TECHNICAL BULLETIN TECH-01-2020

6<sup>TH</sup> JANUARY 2021

# VW 2.0L - 830323-5006S TURBOCHARGER REPLACEMENT

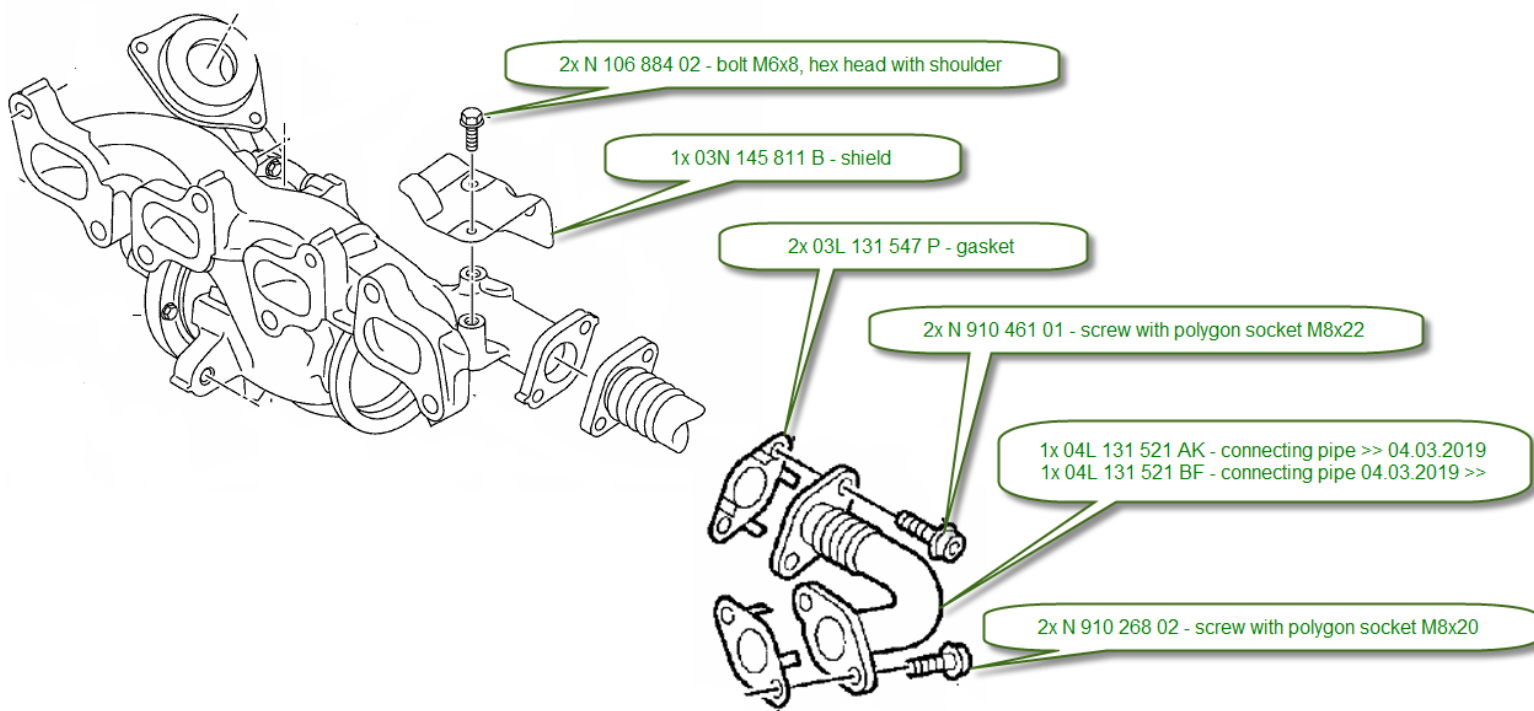
As a replacement is available turbocharger 04L 253 014 M / 873767-5001S, which is not a direct service replacement for 830323-5006S.

- There is a different position of the flange for EGR pipe on turbine housing – see below

- From Garrett - Turbocharger 873767-5001S
- From franchised VW dealer
  - EGR pipe
  - Gaskets
  - Heatshield
  - Necessary fasteners
